APPENDIX N

N2
RESPONSE TO LA-CITY LEA COMMENTS
SUNSHINE CANYON LANDFILL CITY-COUNTY JTD
FEBRUARY 27, 2008

RE: RESPONSE TO LA-CITY LEA COMMENTS
SUNSHINE CANYON LANDFILL CITY-COUNTY JTD

RE: **RESPONSE TO LA-RWQCB COMMENTS**
SUNSHINE CANYON LANDFILL CITY-COUNTY JTD

FIGURE 3-C

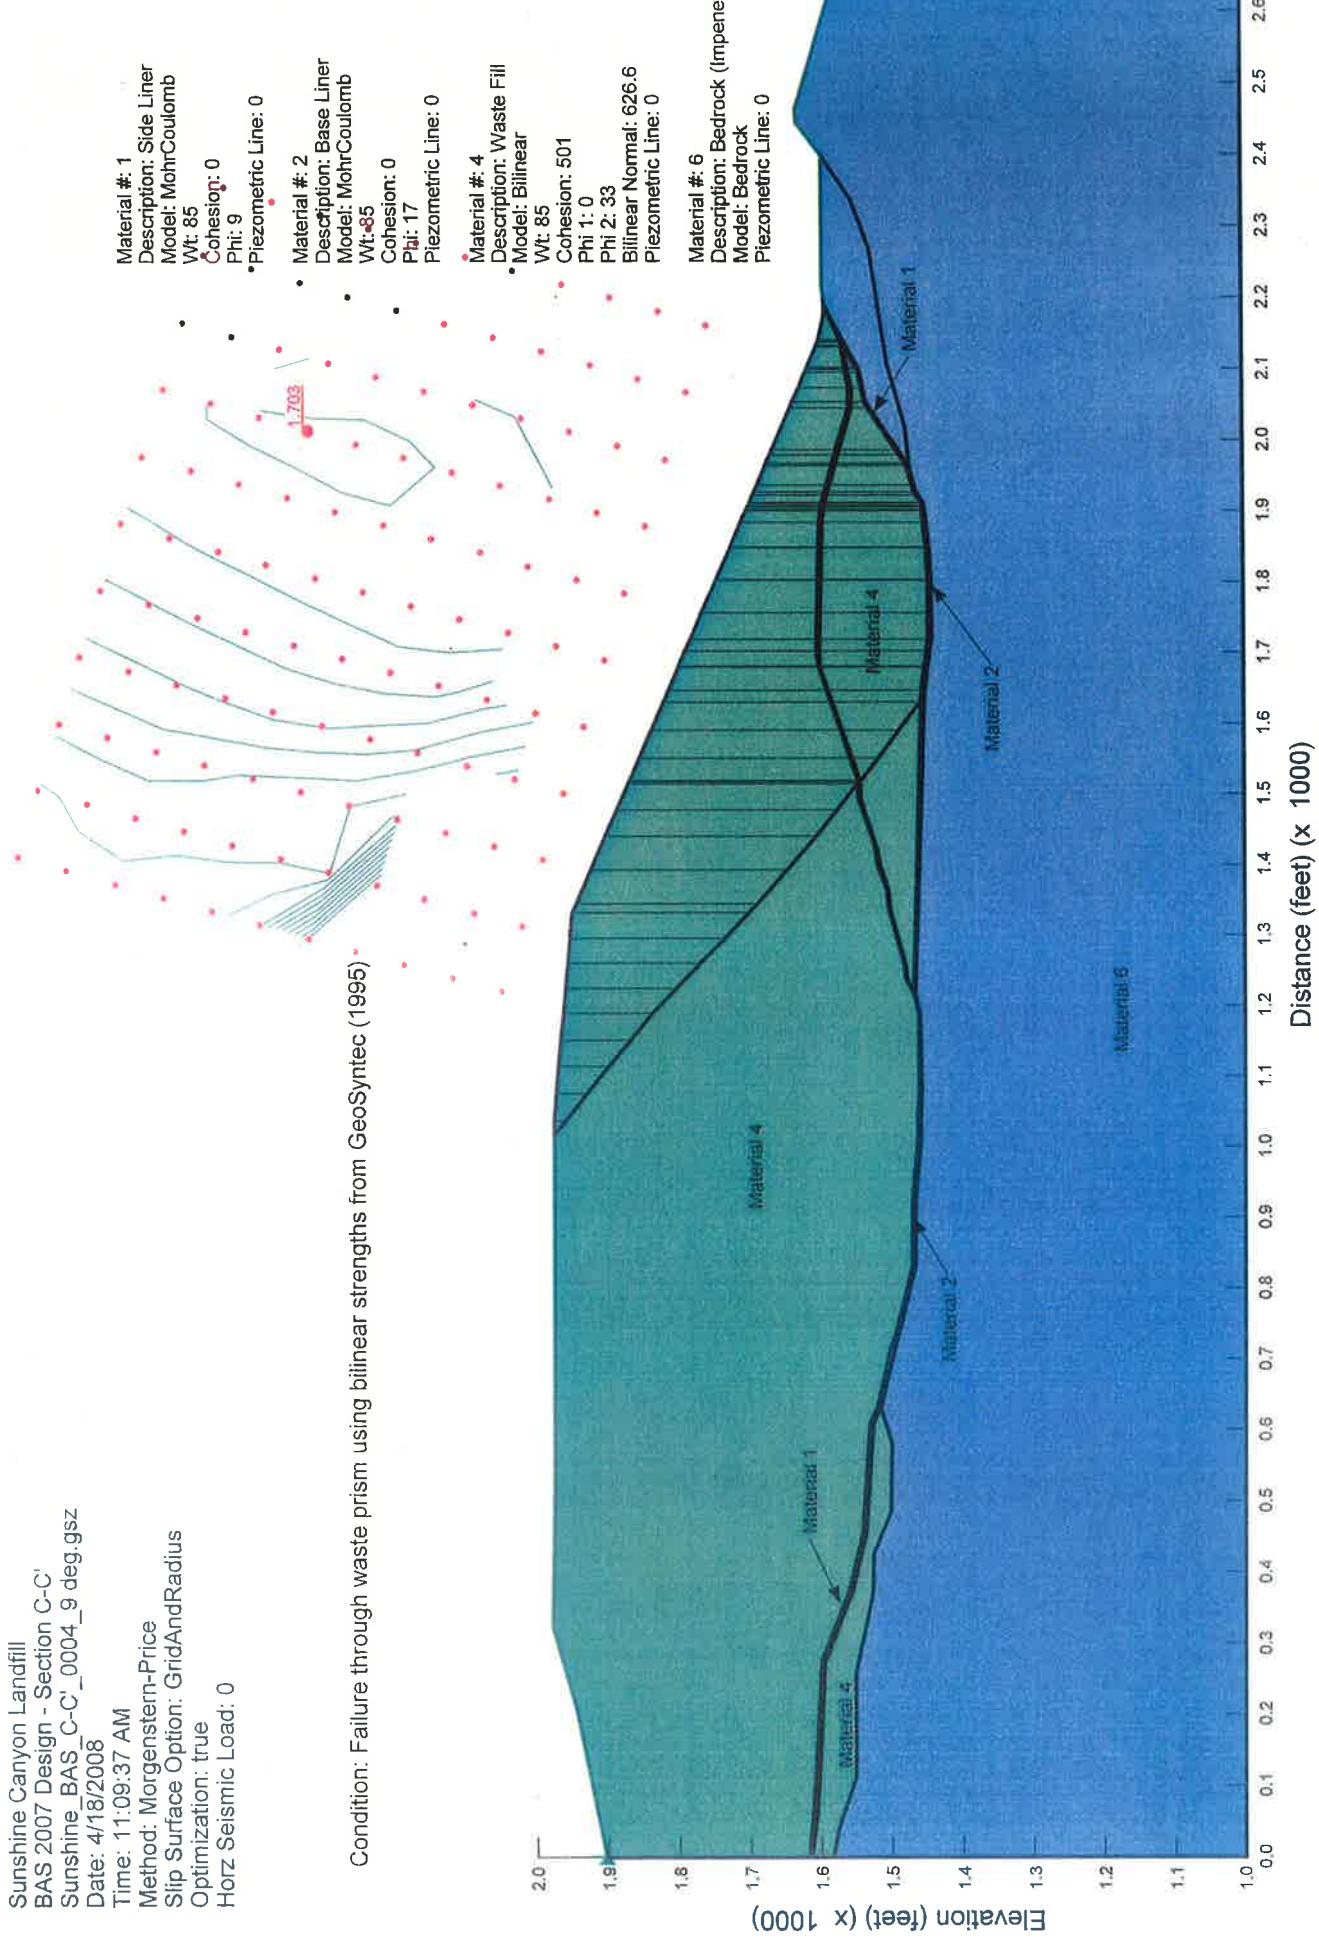
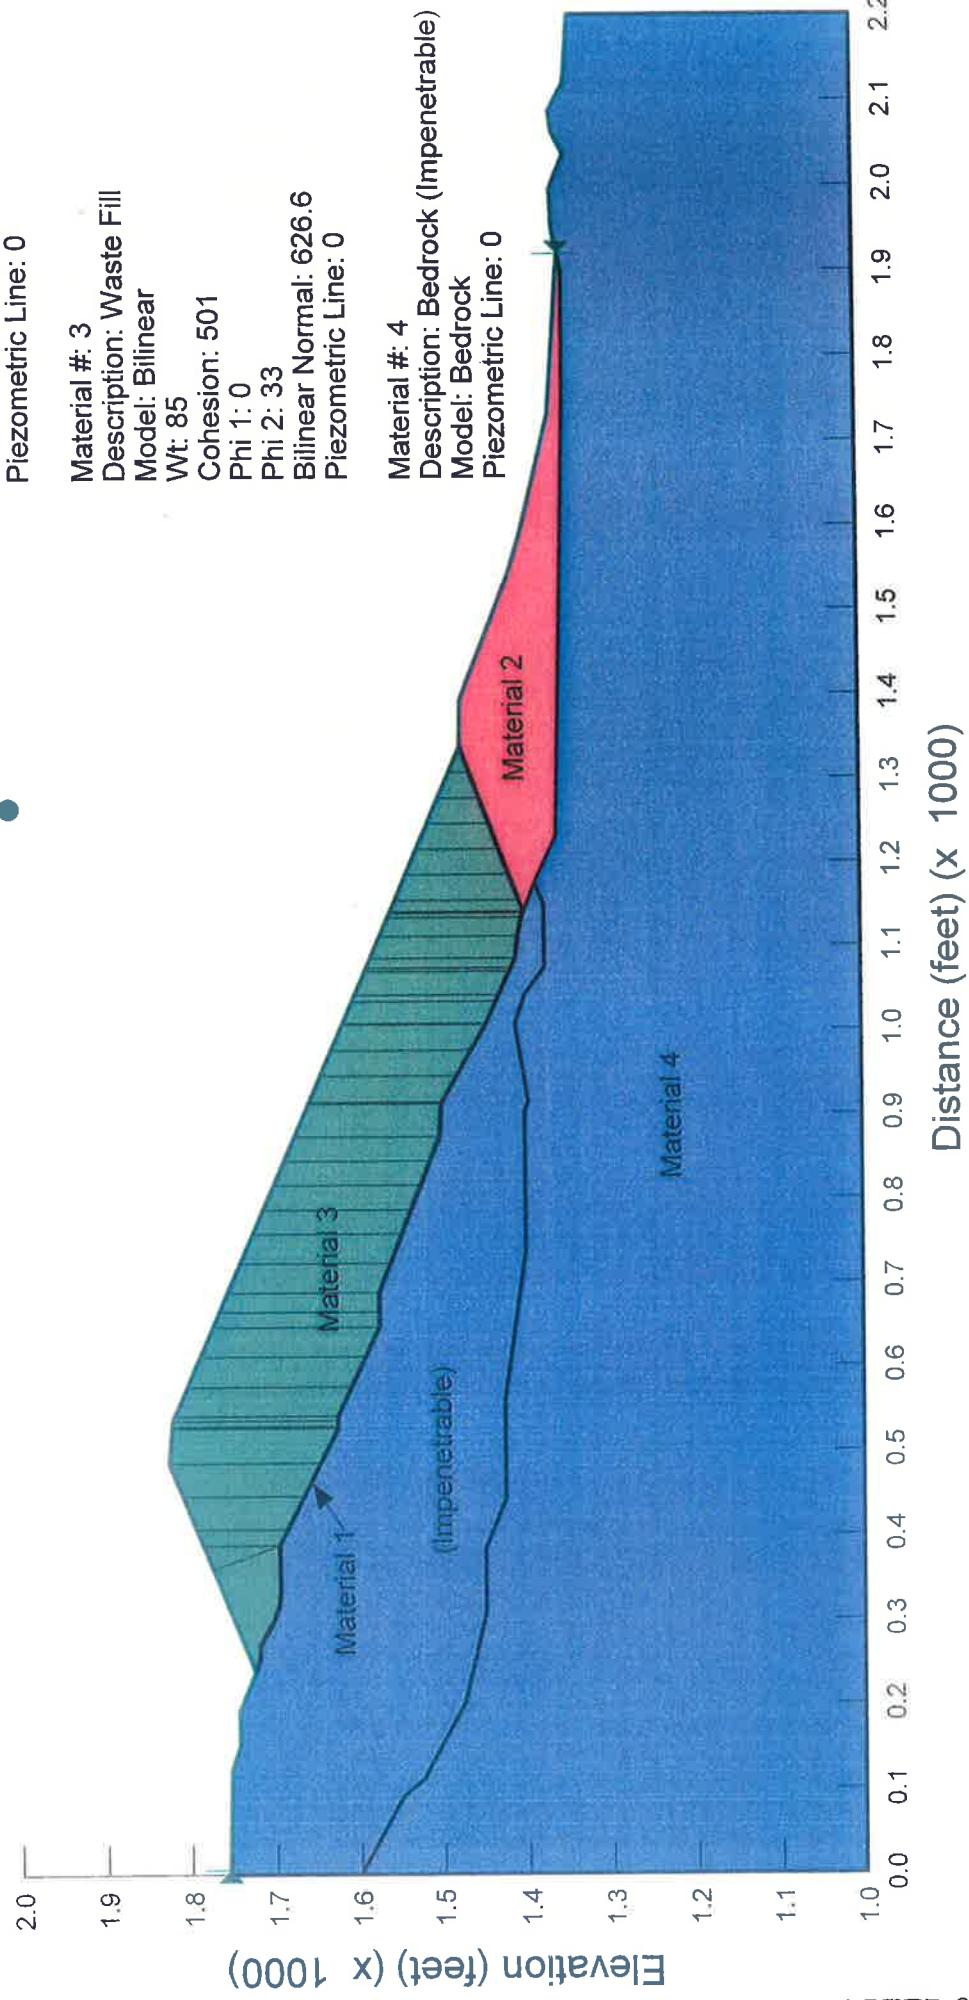
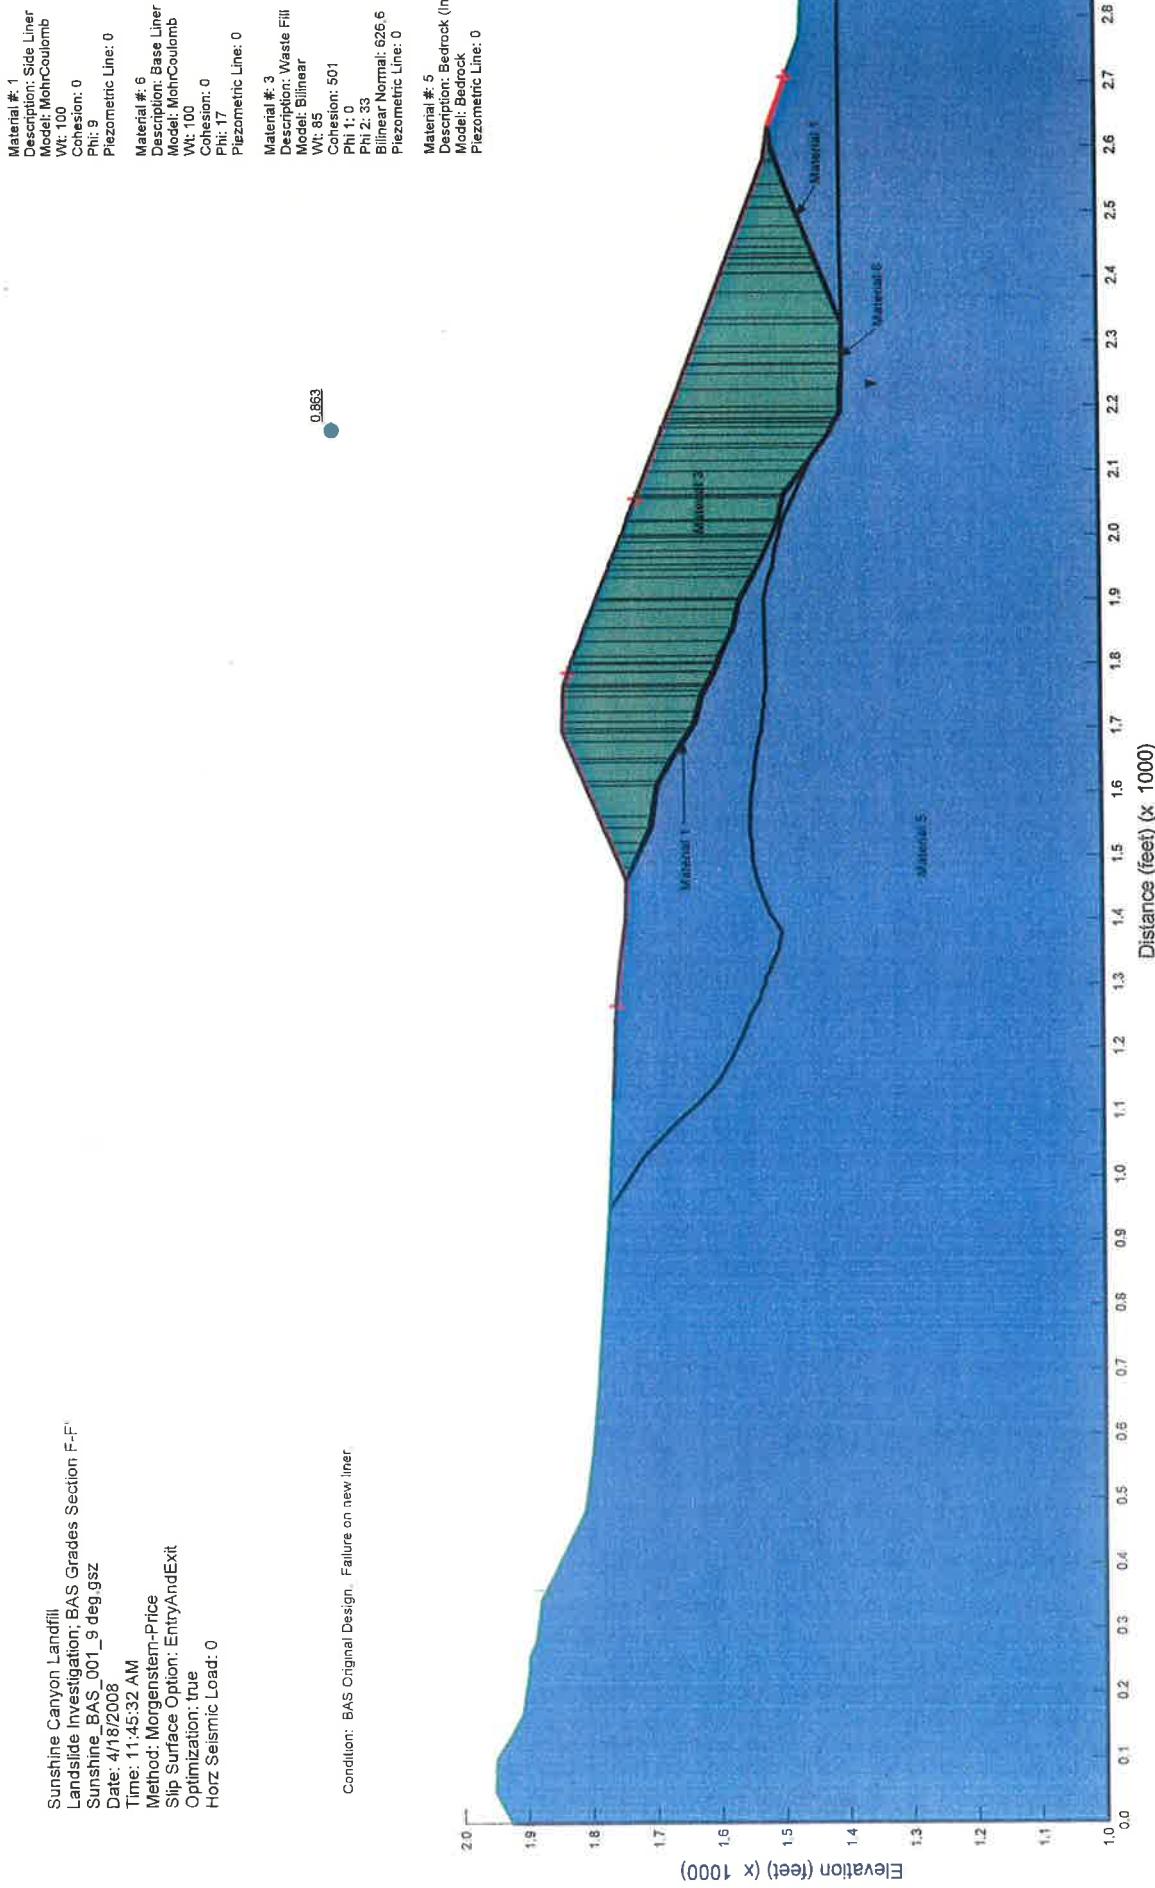
COMMENT 2 – STABILITY ANALYSES: *Appendix N of the JTD includes slope stability analyses that were prepared in 2002 for a previous JTD. However, landfill designs in the new JTD are different from those assumed in the 2002 JTD. Specifically, the new JTD proposes a double composite liner system and a final cover system that includes a low permeability (clay) layer, while the 2002 JTD assumed a single composite liner system and a final cover system that included geosynthetic clay liners instead of a clay layer. We understand that BFI will submit stability analysis design plans for each phase of landfill development. However, stabilities of the overall landfill configuration and final refuse slope must be demonstrated in the JTD. In accordance with section 21750(f)(5) of 27 CCR, stability analyses in the JTD must be updated.*

GLA's reevaluation of material strength characteristics resulted in a recommendation to revise some liner material properties. These somewhat reduced strengths in combination with the more rigorous analytical approach of SLOPE/W (v. 6.22) resulted in factors of safety below 1.5 for the current design along Section E-E' and F-F' (Figures 3-C through 3-F).

Since the low factors of safety along these sections are significantly affected by the relatively low shear strength associated with the smooth HDPE liner interface, it is recommended that the waste-over-waste liner design be modified to incorporate a double-sided textured configuration. While the beneficial effects of this minor design change is reflected in the results presented on Figures 4-C through 4-F, this change, by itself, still does not yield an adequate factor of safety and additional recommended design modifications are presented below.
